Permitting decisions

We have decided to grant the permit for Progress Power Station operated by Drax Power Limited.

The permit number is EPR/AP3936EA.

EPR/AP3936EA/A001 Date issued: 18/01/2019

Graph showing stack height sensitivity testing.

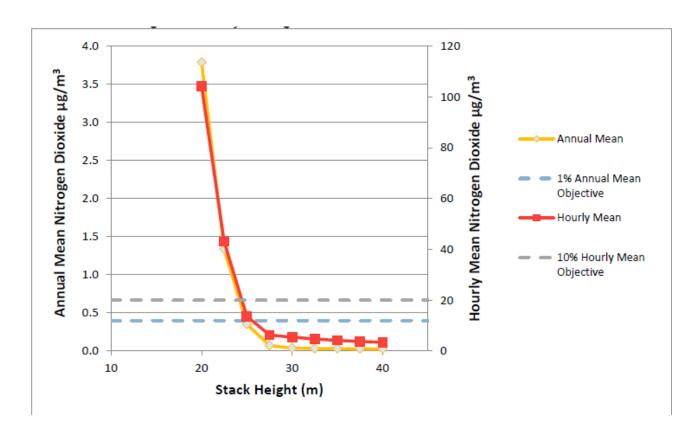
Stack height sensitivity testing indicated that a stack height of 25m would be required to achieve adequate dispersion of emissions, with the maximum ground level concentrations within the receptor grid as insignificant – see graph below. We accept that this indicates BAT for stack height.

We have reviewed these proposal against the requirement of our guidance and are satisfied that at present OCGT presents BAT for serving the peaking market requirement and operational hours.
